# **NEDC et al. v USACE et al:** (Case No.: 3:18-cv-00437-HZ)

## **Assessment of risks to human life and safety from proposed modifications to operations**

**Prepared for: Judge Marco A. Hernandez**

**Prepared by: Desiree Tullos, PhD PE (OR)**

**Figure 3. Landslide susceptibility at Detroit reservoir.** Data source: DOGAMI (2020). See Appendix 1 for summary of methods for assessing landslide susceptibility.

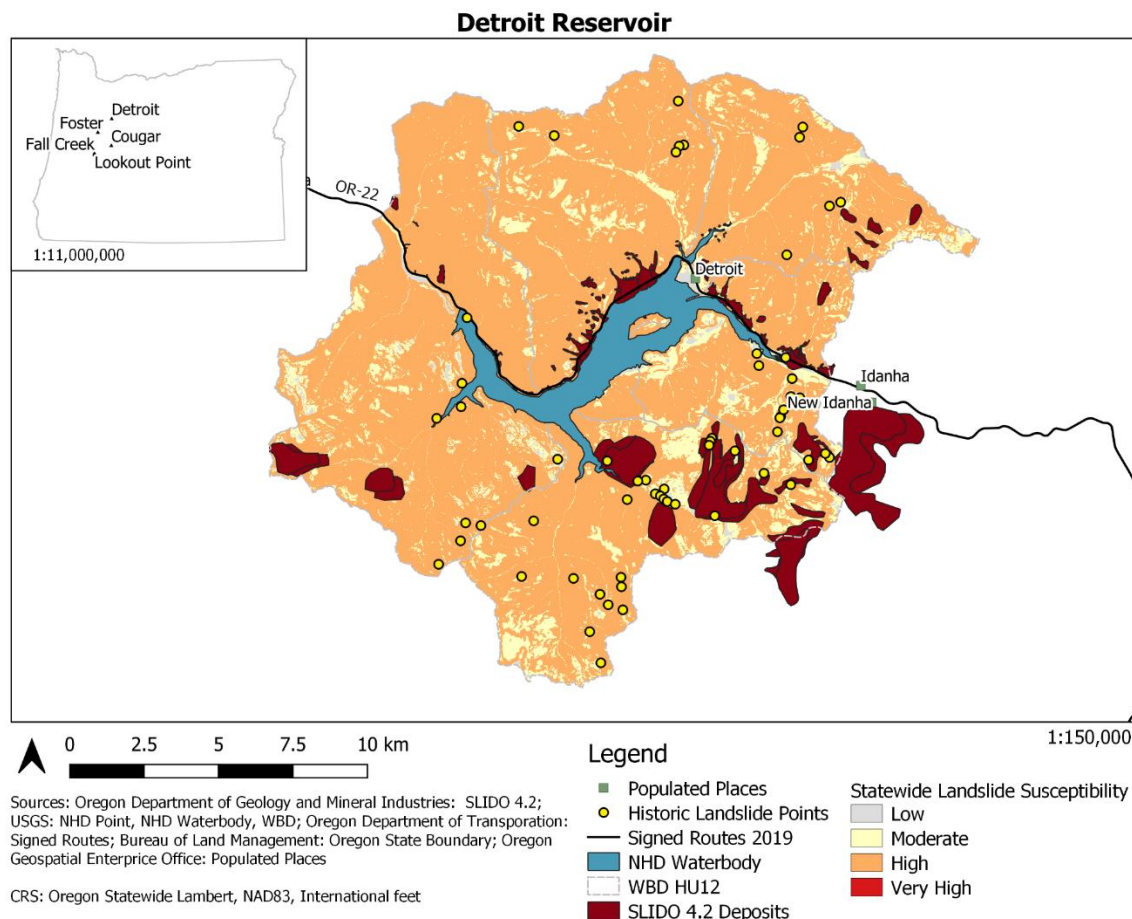
Early drawdown at Detroit (NS1). Achieving the proposed early drawdown at Detroit reservoir would be accomplished by earlier and/or faster drawdown in the fall. Faster drawdown could contribute to issues of reservoir sediment instability. The sediments in Detroit reservoir are composed primarily of fines and sands (McMillan 2018), which are particularly vulnerable to slope failure and vertical and lateral erosion upon rapid draining. I was unable to find documentation on prior drawdowns at Detroit reservoir to evaluate whether an accelerated rate may lead to substantial mobilization of sediments, but I suspect that the volume would not be extreme. However, landslide susceptibility introduces some additional risk to changing drawdown operations at Detroit. Even prior to 2020, most of the surrounding area was mapped fairly contiguously as “high” landslide susceptibility and multiple prior landslides have been mapped along the shore (Figure 3). In addition, the 2020 Beachie Creek fire burned approximately half of the shoreline around the reservoir. Wildfires are known to increase landslide risk in subsequent years as a result of the loss of vegetation and post-fire hydrophobicity of the soils (Shakesby and Doerr 2006). The combination of potential for reduced stability of reservoir sediments, increased landslide risk from the Beachie Creek fire,

the adjacency of Highway 22, and an accelerated drawdown rate at Detroit under NS1 results in a rating of the measure as *minor or mitigatable risk*. To mitigate the risk of destabilizing reservoir sediments, early drawdown should be achieved by starting drawdown one month earlier rather than an accelerated rate of drawdown, though other tradeoffs are expected with an earlier drawdown of the reservoir.

**Figure 4. Landslide susceptibility at Foster reservoir.** Data source: DOGAMI (2020). See Appendix 1 for summary of methods for assessing landslide susceptibility.

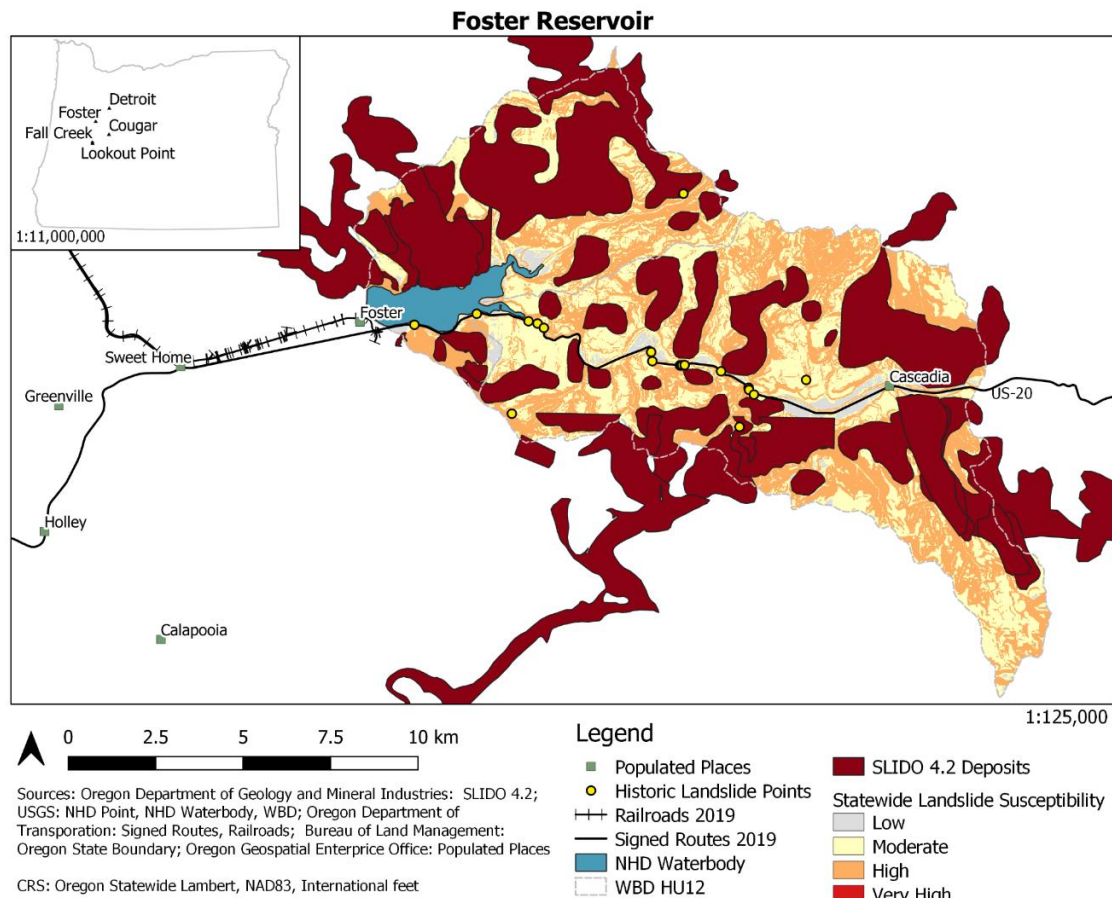
Delayed refill at Foster (SS5). The proposal to delay refill at Foster reservoir is unlikely to significantly elevate instability in the reservoir sediments. Keeping the reservoir at minimum conservation pool through May 15, rather than beginning refill February 01, may result in some increased erosion in the upper portions of the reservoir as spring rains and snow melt runoff

enters the reservoir. However, the reservoir pool will likely trap most of the mobilized sediment and/or small-sized sediment will pass through downstream reaches in suspension.

While this operational strategy is not expected to lead to substantial increases in the risk of landslides, it is noteworthy that the hillslopes around the reservoir are highly susceptible to landslides, and that the adjacency of Highway 20 and the community of Foster increase the consequences should a landslide occur. The reservoir hillslopes have already experienced multiple historical landslides, including several adjacent to the highway, and landslide deposits have been documented along the shoreline (Figure 4). Despite this relatively high risk of landslides at Foster reservoir, the expectation of a limited effect of the proposed operational change (delayed refill) on elevating landslide risk and the trapping of the eroded sediments in the conservation pool lead to this measure being placed in the *no appreciable risk* category.

**Figure 5. Landslide susceptibility at Cougar reservoir.** Data source: DOGAMI (2020). See Appendix 1 for summary of methods for assessing landslide susceptibility.

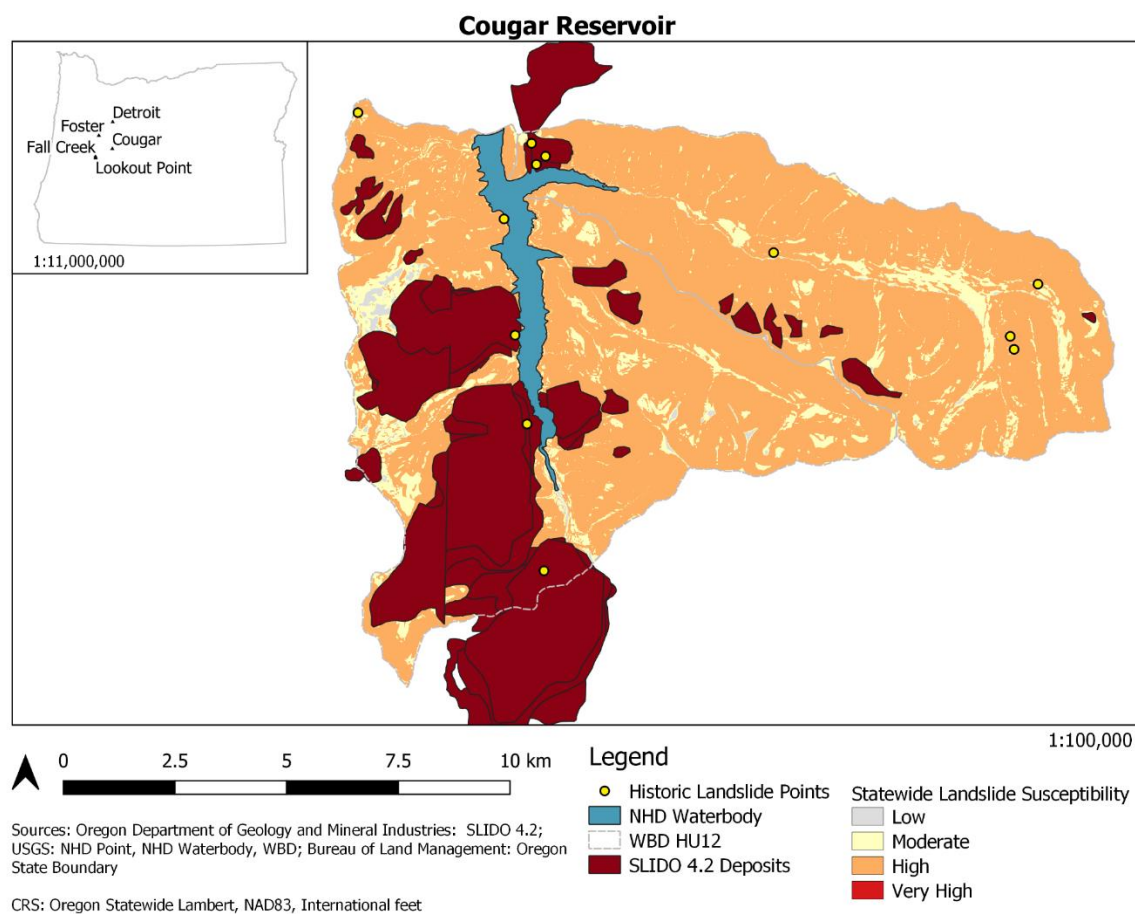
Limited refill and early drawdown at Cougar (McK1 and McK2). These two operational measures are unlikely to increase the instability of reservoir sediments as they will not draw the reservoir down faster or deeper than is scheduled in the rule curve. Cougar reservoir (Figure 5) has documented landslide deposits adjacent to the shoreline, most of the hillslopes are mapped as high susceptibility, and a small portion (~0.3 miles) of the shoreline was burned by the Holiday Farm fire in 2020. However, while landslide risk at Cougar is not low, it is not expected that the proposed measures would result in elevating that risk.

Supporting the assessment of low landslide risk, a prior drawdown of the reservoir that occurred in 2002 for construction of the temperature control tower (Figure 6) did not appear to appreciably affect the landslide deposits. During that drawdown event, some vertical and

lateral erosion did occur, resulting in elevated suspended sediment downstream. In addition, the drawdown also exposed and eroded former landslide deposits that had been submerged under the reservoir, producing elevated suspended sediment concentrations (G. Grant, personal communication). However, while downstream habitats were impacted by the intrusion of fine sediments into spawning gravels (Grant et al 2015), areas of substantial deposition downstream were not documented. As a result, this measure is rated as *no appreciable risk* for elevated sediment instability.

**Figure 7. Sediment loads downstream of Fall Creek reservoir during the drawdown period** (Source Schenk and Bragg 2019). Note the high loads of sediment reaching the downstream USGS gage during the first year of drawdown, followed by smaller loads in subsequent years.

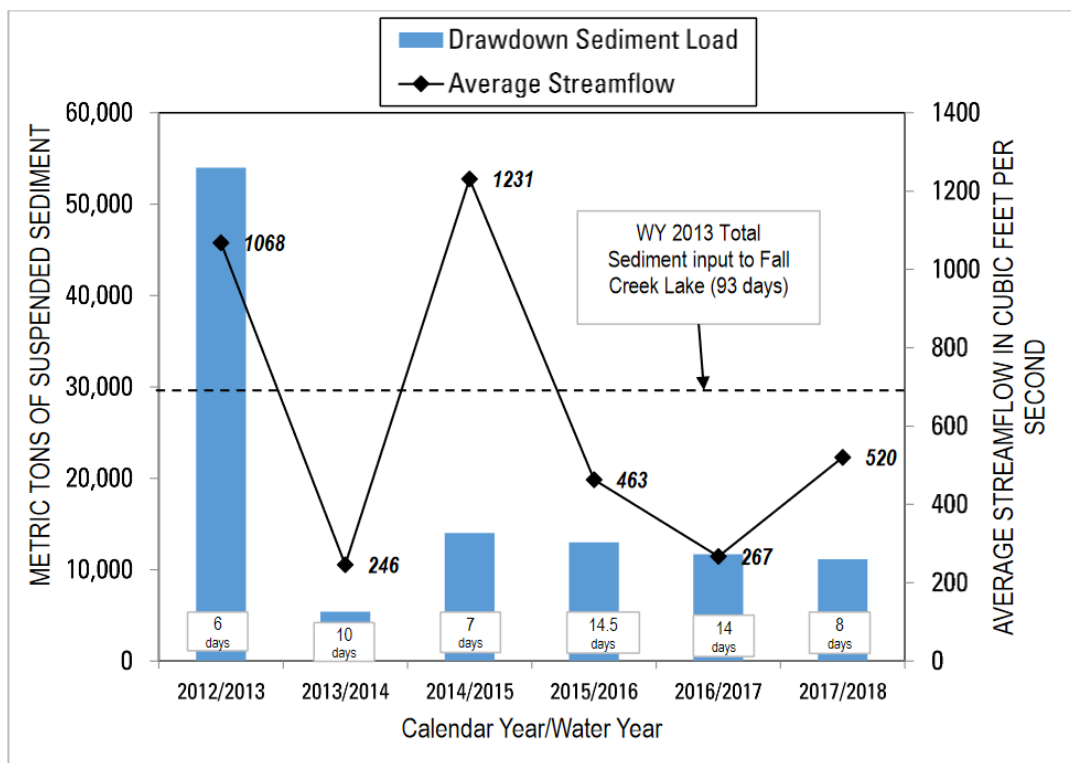
Deep drawdown at Lookout Point (MFW1). This proposed measure would draft Lookout Point reservoir an additional 75' below the minimum conservation pool during November and December to reduce the depth the fish have to swim to reach the ROs for safe passage. Given that a sizable proportion of the reservoir would be drawn down to the streambed, it is expected that this drawdown would lead to vertical and lateral erosion in the clays and fine sands that comprise the reservoir sediments. This is potentially the first drawdown at Lookout Point since its construction (Askelson declaration 159). Thus, the volumes of sediment eroded during the first year may be substantial but are expected to decrease with each annual drawdown as observed in Fall Creek reservoir (Figure 7).

Deep drawdown has occurred annually at Fall Creek since 2012 to facilitate downstream passage. Results from Fall Creek likely represent a similar set of physical processes that can be expected at Lookout Point since the reservoirs are adjacent and have similar sediment compositions. One relevant finding from the study of Fall Creek operations includes the observation that repeated drawdown operations help maintain a well-defined channel (i.e. thalweg) in the reservoir, rather than the channel laterally migrating across the former

floodplain (Keith and Stratton 2019). This finding is important because having a well-defined channel means that other zones of the reservoir, such as the reservoir margins where landslide deposits may be stored, are not as likely to erode. From a risk perspective, the result of a well-defined channel is a limited volume of sediments eroded and a reduced risk of eroding the toe of landslides. This re-occupation of the well-defined channel likely explains the reduction in suspended sediment observed downstream in subsequent years of drawdown at Fall Creek (Figure 7, Schenk and Bragg 2019). A second relevant finding from the study of Fall Creek drawdowns is the observed deposition of sand in side channels and other low velocity zones downstream of the dam, and that the deposition appears to persist in vegetated areas (Keith 2019). To my knowledge, there is no evidence that this deposition has appreciably impacted flood elevations. However, preliminary data reported by the USGS (Keith 2019) indicated that local deposition of up to 1.6m occurred at one location after the 2016 drawdown of Fall Creek, though depths were generally lower than that and not detectable at the reach scale.

**Figure 8. Landslide susceptibility at Lookout Point reservoir.** Data source: DOGAMI (2020). See Appendix 1 for summary of methods for assessing landslide susceptibility.

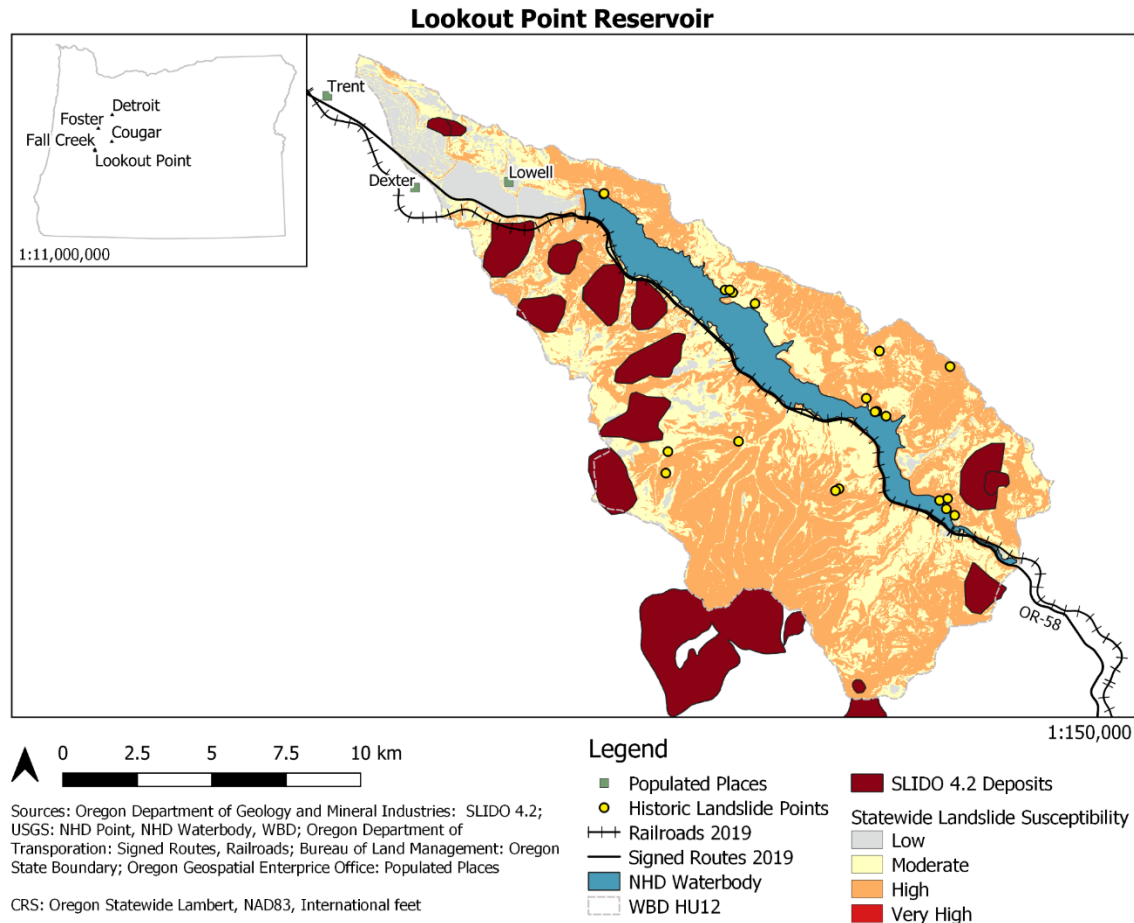
With respect to landsliding, historical landslides have occurred in the reservoir and landslide susceptibility is mapped as high to moderate for the adjacent hillslopes (Figure 8). While the landslide susceptibility at Lookout Point is not the highest of all of the Cascade reservoirs, the deeper drawdown represents some increased risk of landsliding, particularly near the dam and in a year with large amount of rainfall in November and December when the hillslopes may already be nearing saturation during the time of drawdown. Given the near location of key infrastructure (OR-58, railroad) and the history of landsliding at Lookout Point in

response to valley ponding (Howell 1952), this particular risk requires further investigation. Thus, given the uncertainty surrounding how much stored sediment may be transported downstream, the uncertainty in how deep drawdown may impact landslide susceptibility, and the local infrastructure at risk should landslides occur, this measure has been categorized as having *high likelihood or consequence risk*. The risk category could be reduced to *minor or mitigatable risk* with additional information:

1) Results from hillslope stability models that characterize the local-scale hillslope-reservoir hydrogeology at Lookout Point will clarify what portions of the hillslope are hydraulically-connected to the reservoir, whether, where, and when deep drawdown may contribute to landsliding, and what infrastructure may be at risk should landsliding occur; and

2) From a life safety perspective, a GIS-based geomorphic analysis of the channel downstream of Dexter Dam should be adequate to identify likely locations of deposition for reservoir sediments and evaluate whether that deposition would appreciably affect flooding. Additional reservoir-river hydrodynamic modeling would only be warranted if substantial landslide risk was found and/or the geomorphic analysis indicates substantial flood risk may result a sediment pulse from Lookout Point.

**Figure 9. Landslide susceptibility at Fall Creek reservoir.** Data source: DOGAMI (2020). See Appendix 1 for summary of methods for assessing landslide susceptibility.

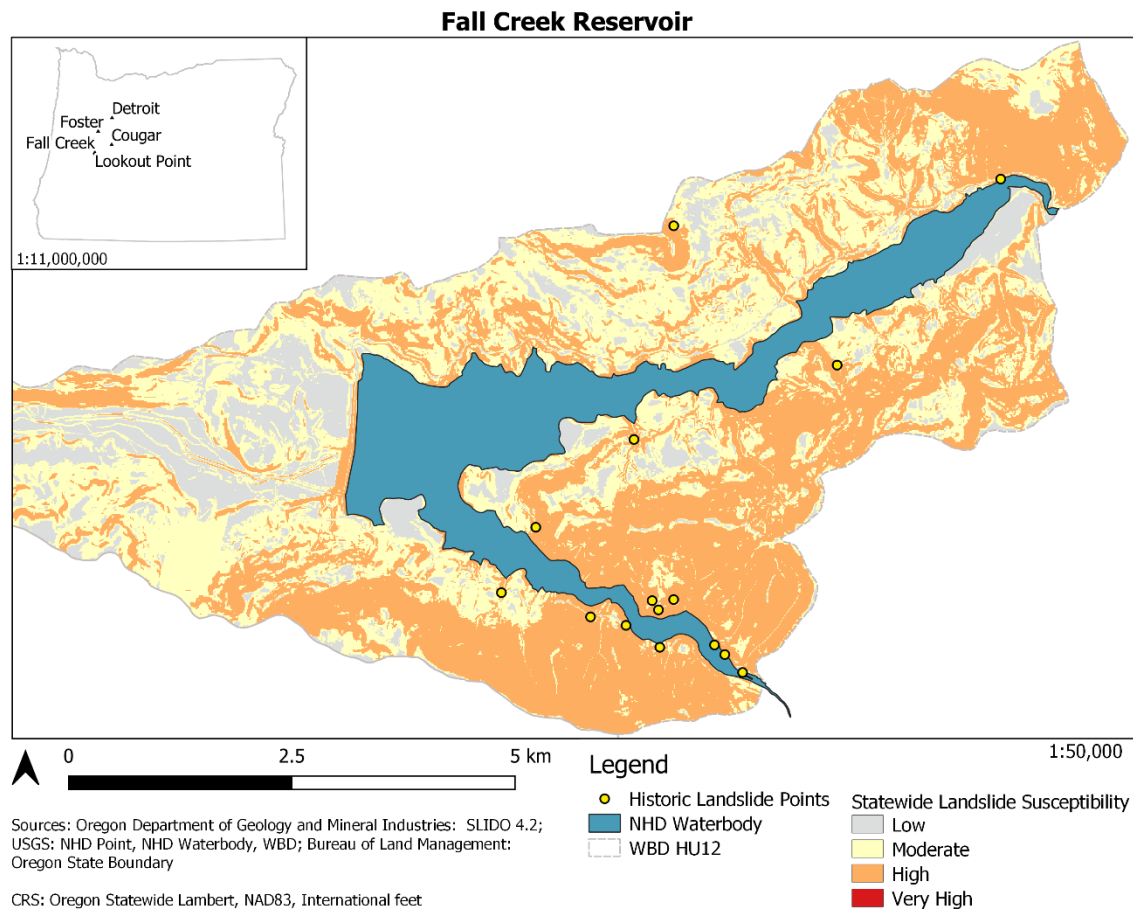
Extended drawdown at Fall Creek (MFW9). This proposed measure would extend the deep drawdown of Fall Creek through January 15 instead of ending in early December. As discussed above, the drawdown operations at Fall Creek for juvenile fish passage are representative of a case where drawdown has produced vertical and lateral erosion, the rates of which have declined over time. A longer duration of holding the reservoir at the streambed would likely increase sediment export (Keith 2019) associated with erosive winter events, though the volumes of sediment are not likely to be large, given that the reservoir appears to maintain its well-defined channel. With respect to landslides, unlike many of the other Cascade reservoirs, the susceptibility to and consequences of landslides in Fall Creek reservoir are not high (Figure 9). At Fall Creek reservoir, the landslide susceptibility is generally low to moderate and is discontinuous in space. In addition, while historical landslides have occurred in the basin, they were upslope or in the upstream portion of the reservoir. Currently, there are no documented

landslide deposits and there is minimal infrastructure that would be impacted by a landslide should one occur. Thus, based on the expectation that the operation is unlikely to erode large volumes of sediment or trigger hillslope instability, this measure is rated as having *no appreciable risk*.
